# TECHNICAL SERVICE BULLETIN

Bulletin Number: V-17-02

**SUBJECT: 2010-17 Victory Cross Country / Cross Country Tour / Cross Roads /  
Magnum / Hard Ball brake line routing**

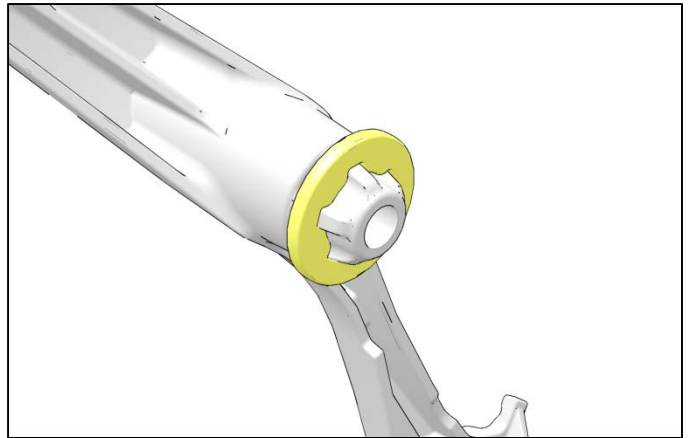
Install the swingarm guard over the footrest bracket until fully seated.

**IMPROVED LINE ROUTING**

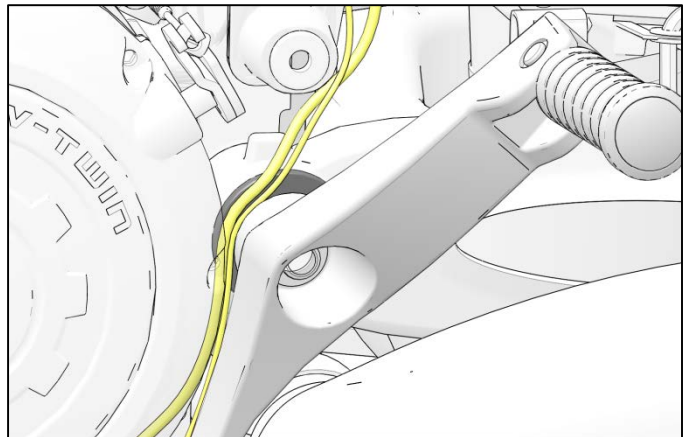
Route the brake line and oil pressure switch lines over the footrest as shown. Assemble the footrest over the swingarm pivot until fully seated.

*\*ABS model routing shown for illustration.*

Verify the brake line and oil pressure switch lines are not pinched between the footrest and swingarm pivot.
